**Draft submission on Evanston Park Code Amendment.
Provided to Special Council meeting (16/5/2023) for information.**

Evanston Park Code Amendment, 550 – 554 Main North Road

Draft Submission on code amendment for 550-554 Main North Road, Evanston Park (Vadoulis Code Amendment)

Figure 3. Proximity analysis for site 6

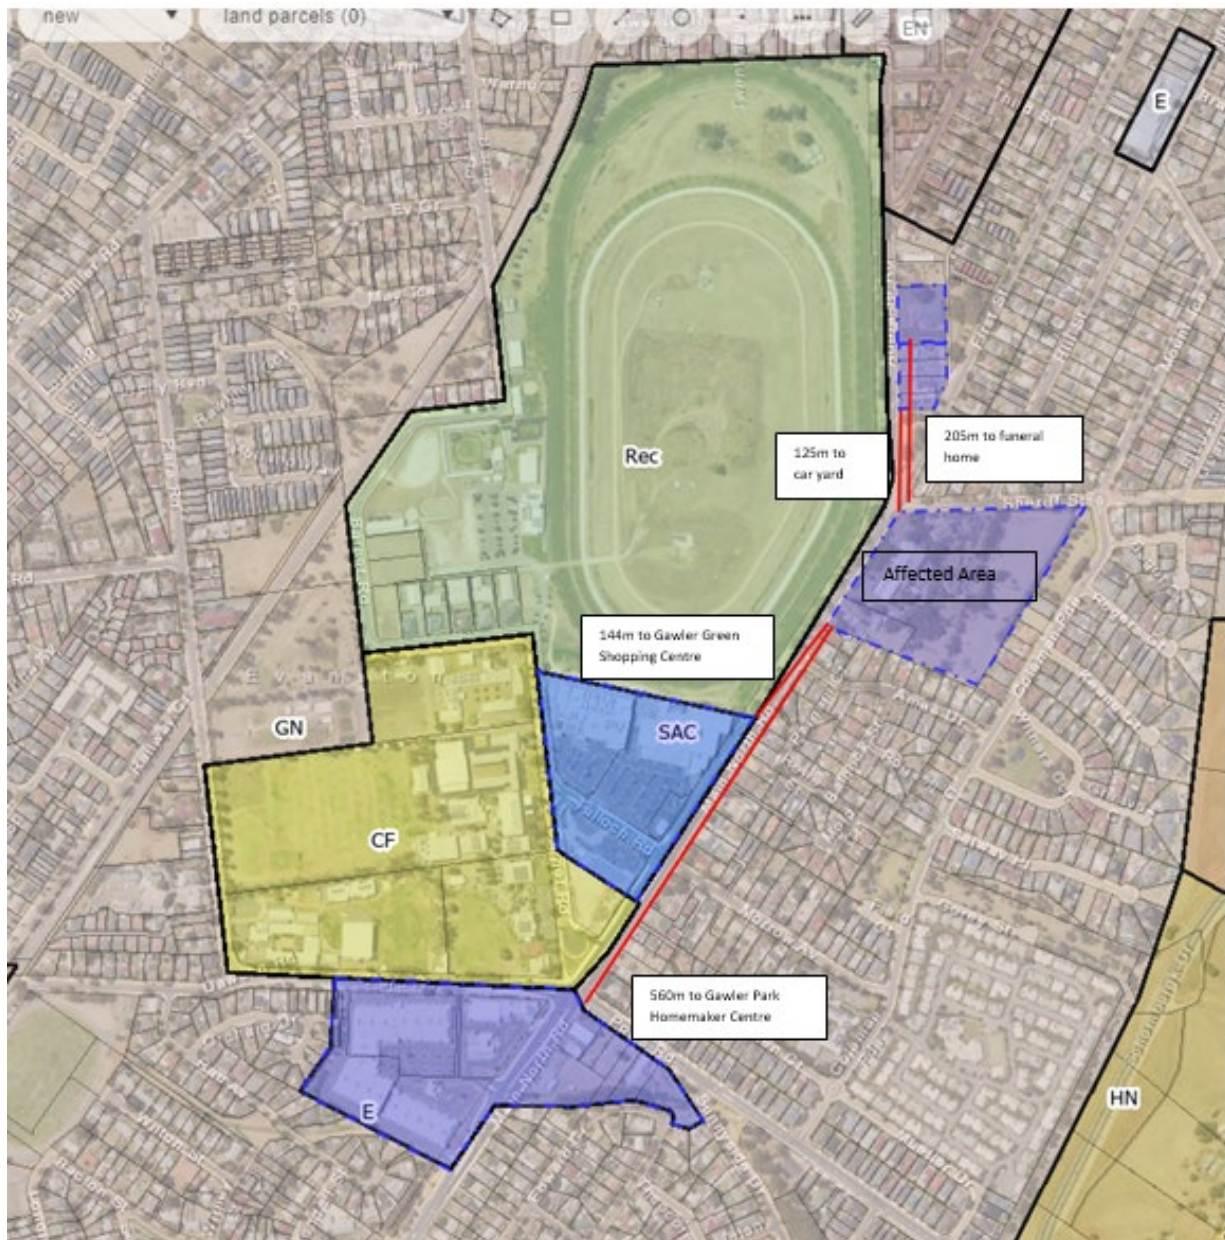
Site 6, or the *Affected Area* (CT5821/328 and CT5719/768), has broad merit for further consideration on the following basis:

- Located within an established urban environment, not a 'green break' typical of Council's historically stated goals in the Southern Rural Areas.
- Has the requisite area for home maker style buildings.
- Has the requisite arterial road frontage.
- In a landownership context is simple to manage.
- Has a history of commercial use extending some 40 years.
- Is part of a corridor of commercial uses that is well established on Main North Road (see Figure 3). Whilst there are some residential uses along this same corridor, these commercial uses already established are of a scale and form that recognise diversity of land use well beyond an over-riding focus on residential amenity.

The *Affected Area* does have some constraints that warrant attention:

- Stormwater drainage capacity has been flagged as a matter requiring design solutions to be applied.
- Sheriff St junction geometry currently allows a left out movement onto Main North Road and from secondary roads more broadly to the proposed bulky goods site. This is not desirable and in staff opinion, will be a potential future problem if not managed.
- Direct interface on two sides with residential (sensitive) uses requires careful consideration eg height, scale, setbacks. Any future development will be considerably larger in scale than the existing Vadoulis Garden Centre.
- Relatively busy arterial road requiring careful management and a design solution securing Department of Infrastructure and Transport (DIT) approval.

Weighing up the merits of site 6, it is considered that the constraints require solutions to mitigate future developmental impacts, either through the Land Management Agreement (LMA), the Development Application (DA) design drawing set and consent conditions process or both. Equally, a range of solutions exist to manage impacts – through modifications already suggested by Future Urban, by additional modifications suggested by Council staff or via DA consent conditions.

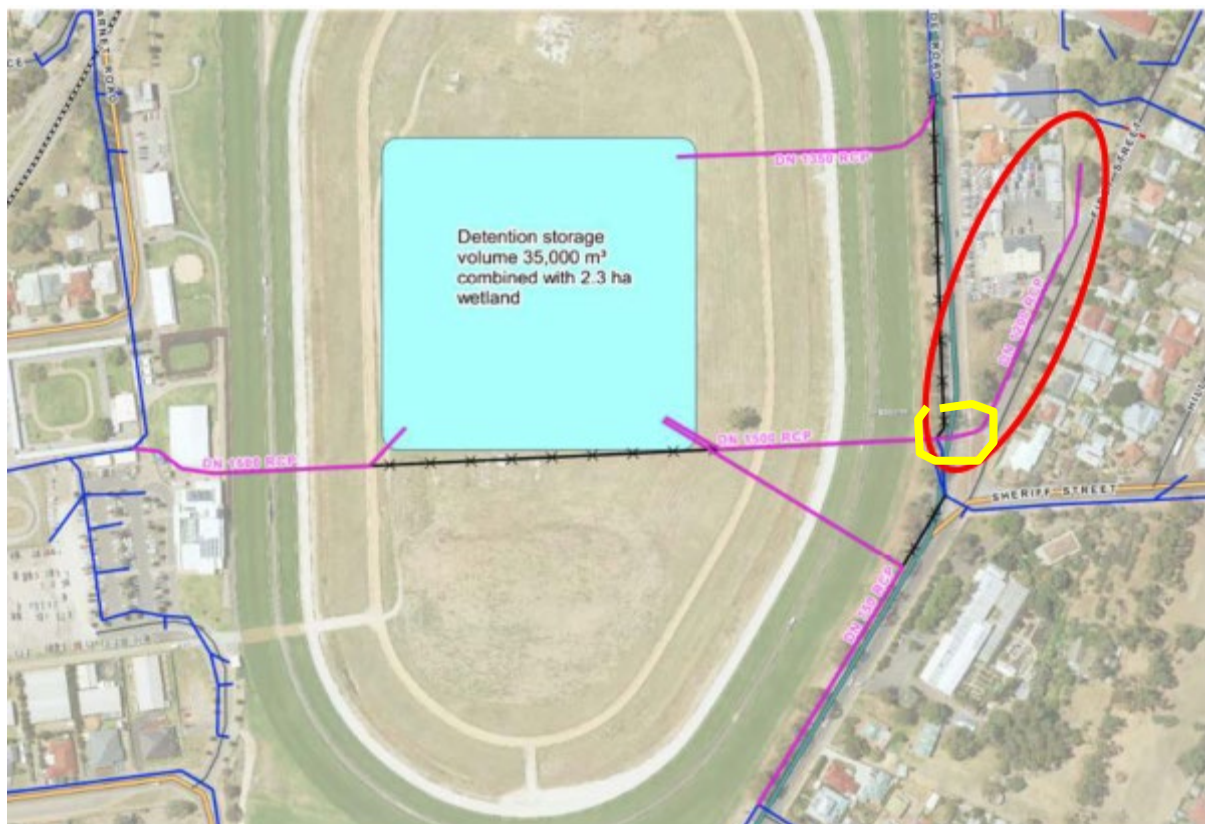
The proposal to upgrade the drain between the First Street drainage reserve and the GBJC boundary would form a key part of a network upgrade that seeks to convey floodwaters more efficiently from the flood affected residential area to the future flood control basin in the centre of the GBJC land. As indicated, this has been costed at \$1.04M under Council's peer review process by CostPlan on behalf of Southfront Consulting Engineers.

In the short term, until the basin is established, the increased pipe capacity reflected by works within the red circled area (Fig 14) would offer limited benefits as the capacity 'bottleneck' across the GBJC site would remain. The short-term benefits would be limited to the marginally increased underground flood storage capacity created by the larger underground pipe.

Therefore, pipe upgrades will relate to upsizing the existing 800mm pipe beneath Main North Road to 1200mm, concurrent with other works (junction upgrades at Sheriff/First Av/Main North Road as addressed elsewhere in this report) to provide for future system upgrades as per Figure 4.

2. Southfront Consulting Engineers calculated the costs of upgrading pipework as generally set out in Figure 4 (within the area circled in red) at \$1.04M. This is over and above the cost set out in 1 above. The *Designated Entity* has agreed to fund 50% of this cost.

Figure 5. Option 1 Closure of First and Sheriff Streets to Main North Road

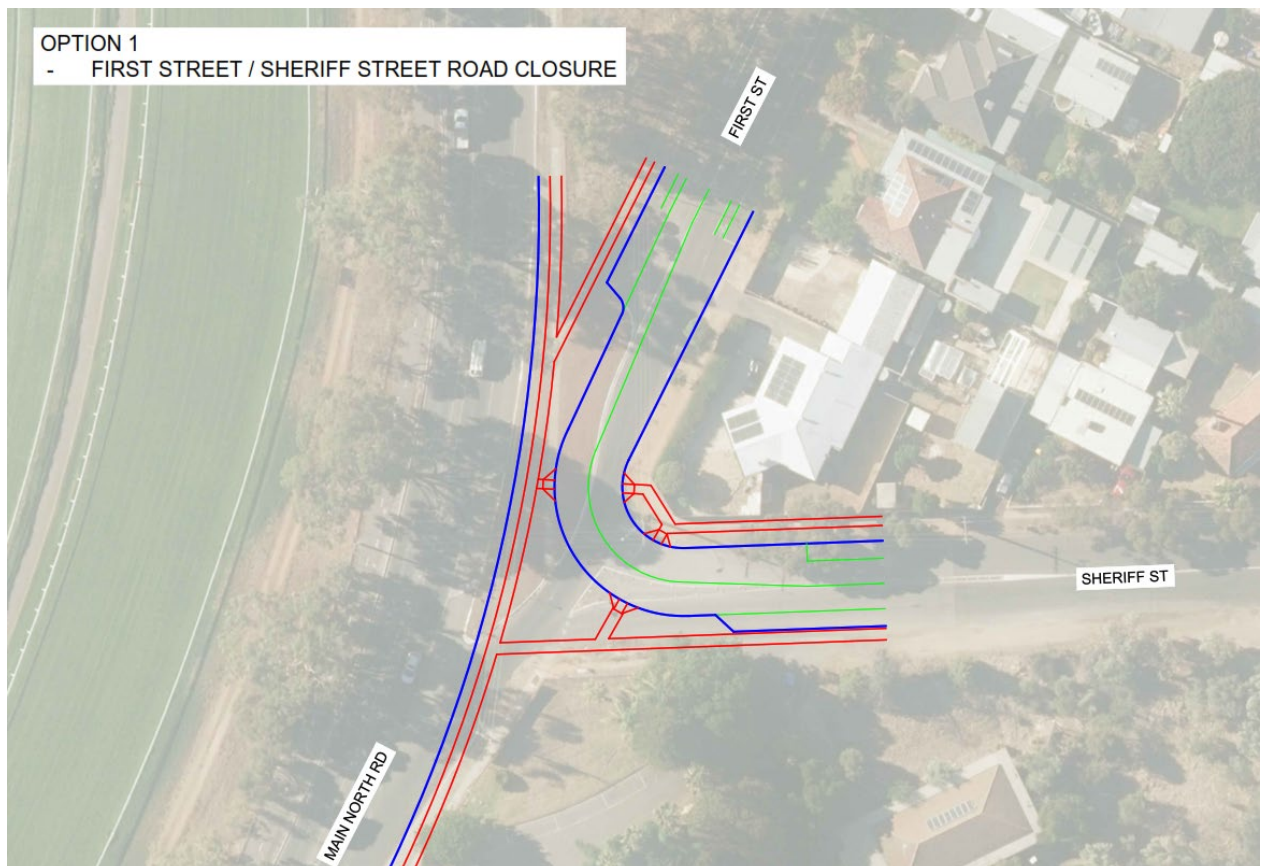
Option 1 is preferred by Council's administration as it eliminates entirely the opportunity for "cut through" in this area.

It is recommended that Council, as the local road authority, fund up to 50% towards the junction modification proposed for First Street / Sheriff Street intersection modification due to the issue being largely pre-existing and only brought forward for resolution under the Code Amendment. The junction modification has been costed at \$128,237.

Figure 7. Option 3 Re-alignment of First Street and Sheriff Street with left turn out

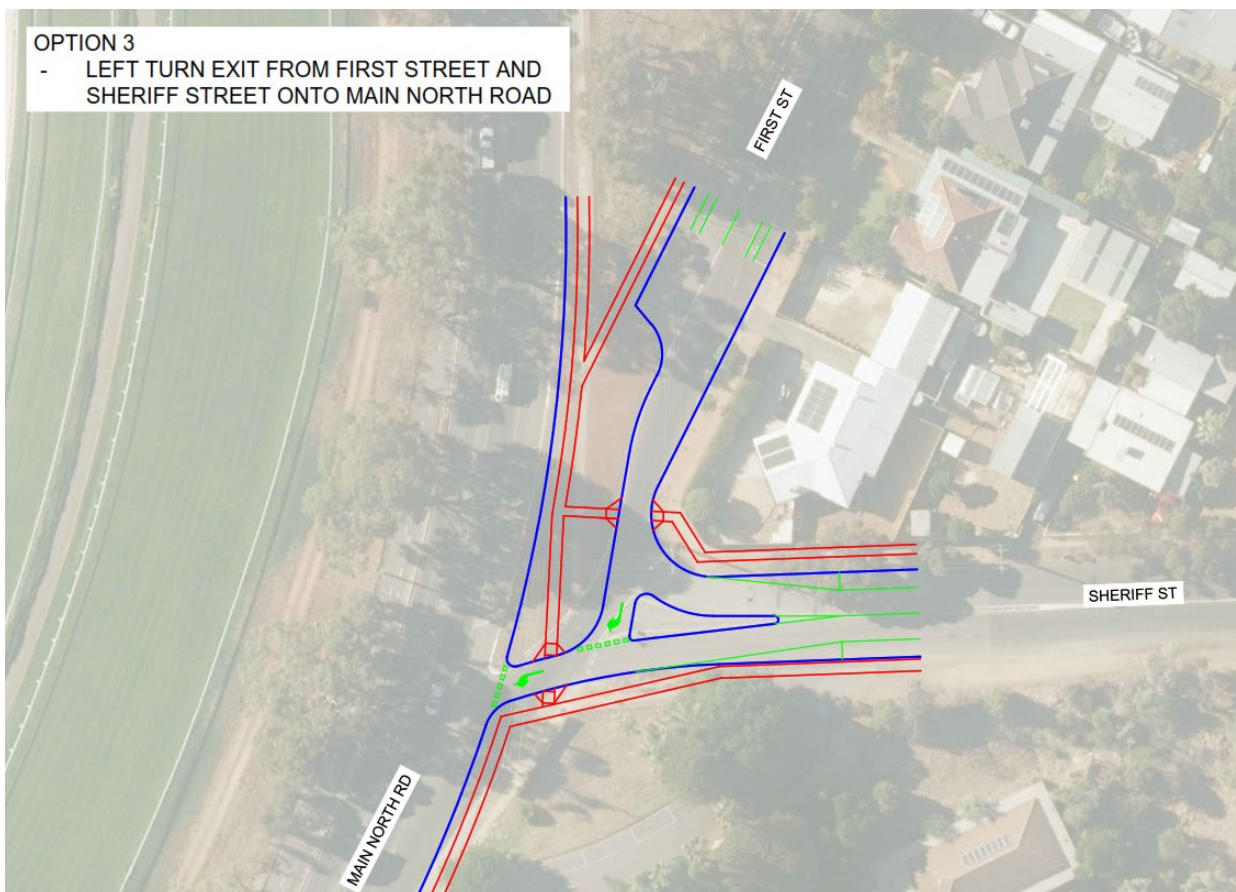
All of the above options including additional options could be considered as part of further Council engagement, should the code amendment be approved by the Minister for Planning.

Figure 11 A. Site plan scale assessment, as exhibited by Future Urban (13m building height)

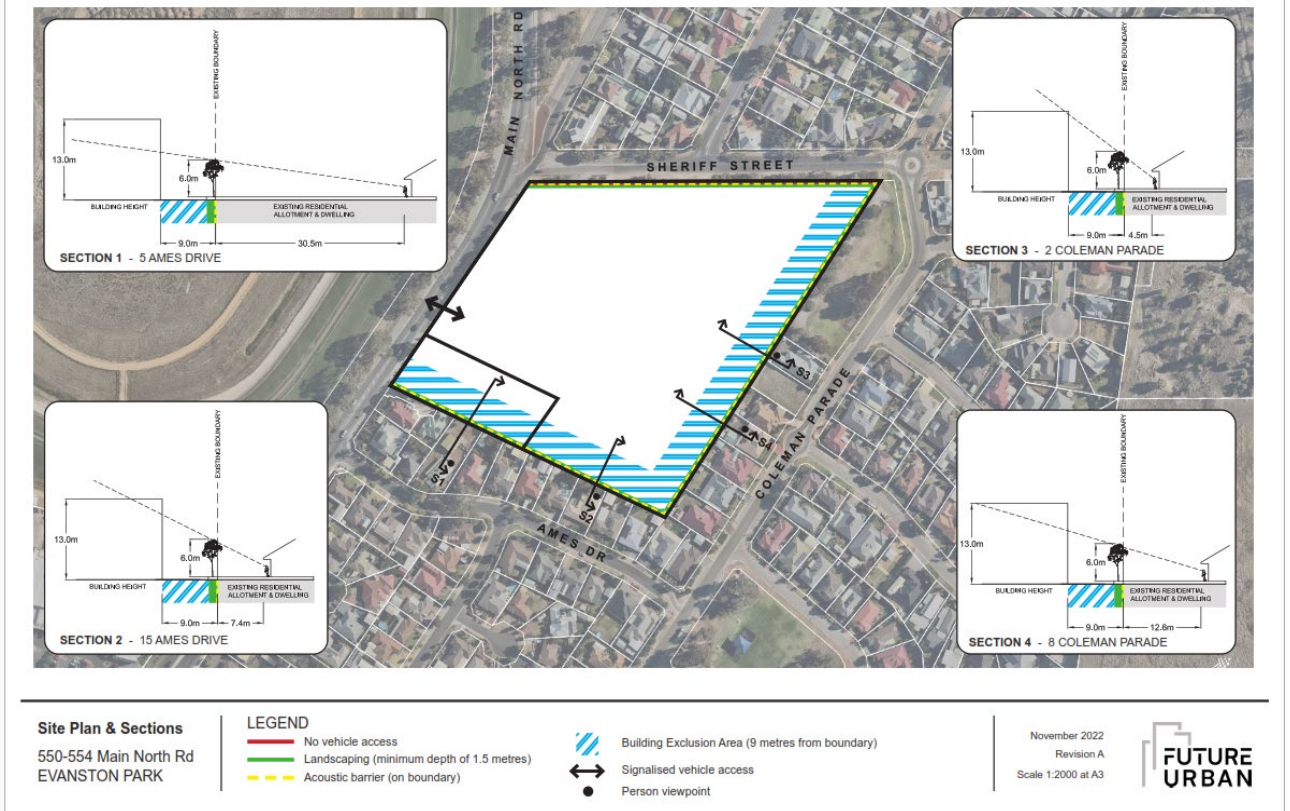
The modifications to the concept plan are supported by Council administration as a significant and measurable improvements in the proposal. Alterations to the building height have reduced the impact (visibility) for neighbours. This is visible in Figures 11A and 11B. The test is not that any new building upon the Affected Area is fully screened from

neighbours, but rather that it not overshadow and or significantly impact on neighbouring visual amenity. As amended (11.5m height), the building will not be visible from 2 of the 4 view lines (sections) shown. For those where visible, the impact is lessened and largely incidental in nature. The proposed changes are consistent with Council’s previous request to demonstrate a design solution that is respectful of the neighbourhood.

With respect to how development may be delivered on-ground, the Designated Entity has proposed a number of planning variations to the code amendment, reflected in the LMA. These include a reduced building height from 13m to 11.5m and increased vegetated buffer

Figure 12. Shadowing analysis, winter solstice (June 21), at 9am, 12pm and 3pm

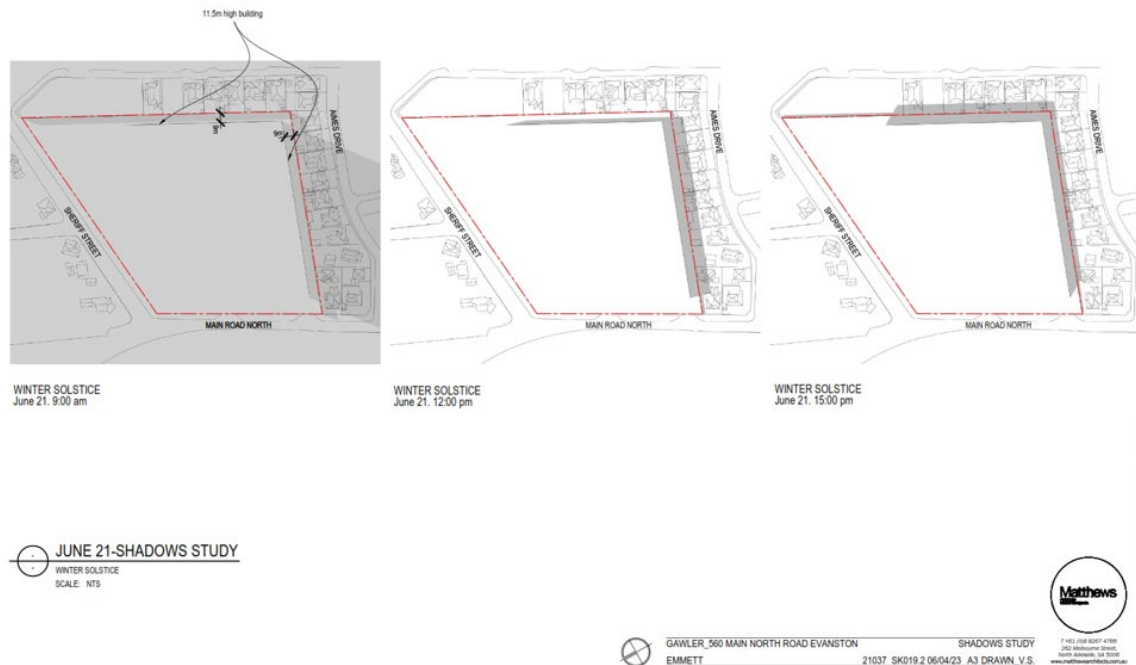
A final consideration is shadowing impact. With the reduced 11.5m building height, at 9am on June 21 (winter solstice) shadowing of neighbours in Ames Drive is observed. This impact is negligible at 12pm and almost completely absent at 3pm. No impact of Coleman Parade or Sheriff Street is modelled under any scenario as these are north or east facing streets.

The shadowing impact is considered acceptable. This conclusion is reached on the basis of Code provisions at PO3.1-3.2. The Deemed to Satisfy (DTS) standard for overshadowing windows of habitable rooms of adjacent residential uses is 3 hrs sunlight between 9am-3pm on 21 June. DTS is achieved.

For private open space (PO 3.2) the DTS standard is 2 hrs of direct sunlight across an area of no less than 35m². The shadow plans establish that 3 hrs or beyond is achieved.

Figure 14. Sheriff Street Cross Section

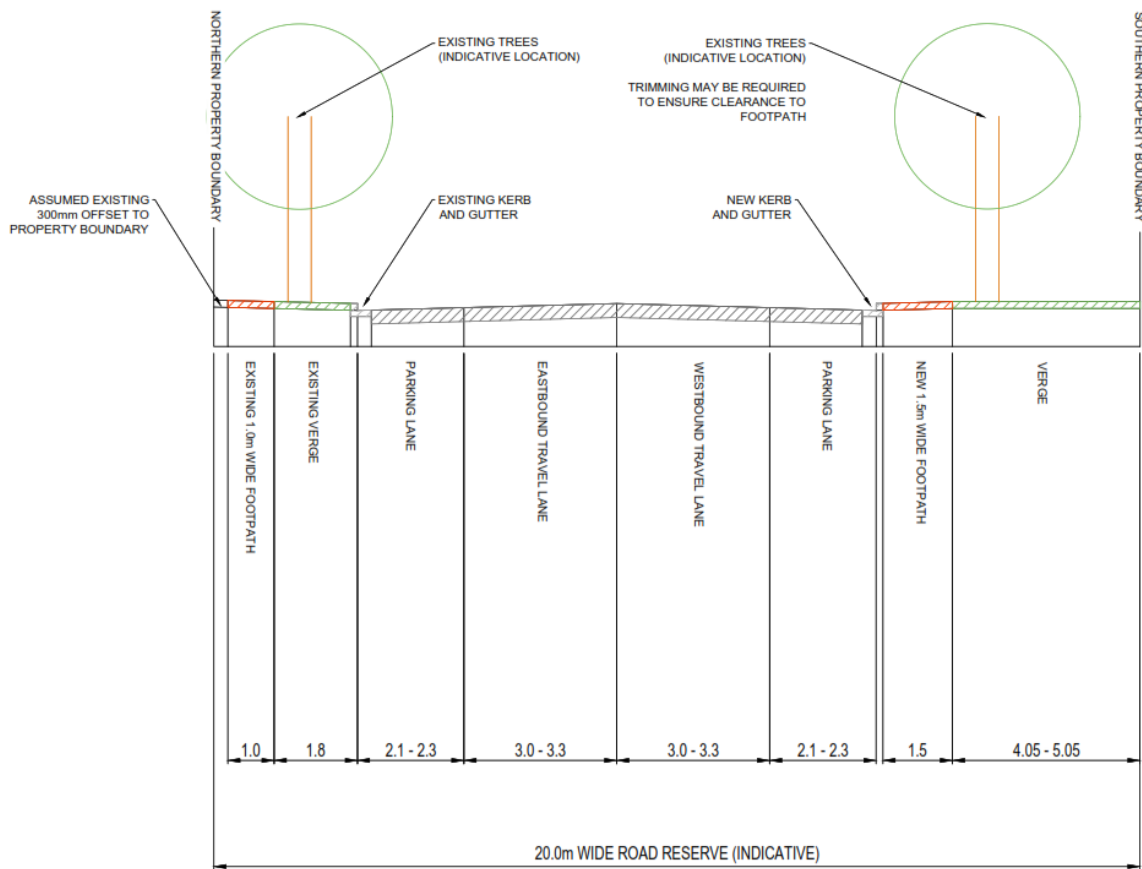
A material improvement in the streetscape and landscaping is also expected along Sheriff Street. Tree enhancement via supplementary planting will occur to strengthen street tree character. This measure together with addressing drainage, footpath construction (at 1.5m width) and conversion of what is a rural standard road into a landscaped urban street. This upgrade to Sheriff Street will be 100% the cost of the *Designated Entity*.

Having regard to Sheriff Street and providing visual separation from the Affected Area, there are two considerations – the benefit of an approx. 22m wide separation generated by the road reserve; and the acoustic wall being built on or near the property boundary at a height of 2.4m (see Sonus report, p8). Presently there is no formal footpath and landscaping is limited in sections of Sheriff Street.

- the concept plan and LMA will specify that the acoustic wall is articulated along the road boundary, not a singular plane. A simple acoustic wall without articulation is undesirable aesthetically;
- the footpath and pedestrian movement should be built abutting the road reserve to enable more scope to retain existing trees within the road reserve; and
- new tree planting between the road reserve boundary and footpath should be undertaken as per advice provided by Council's Landscape Co-ordinator (see 4.4 of report).
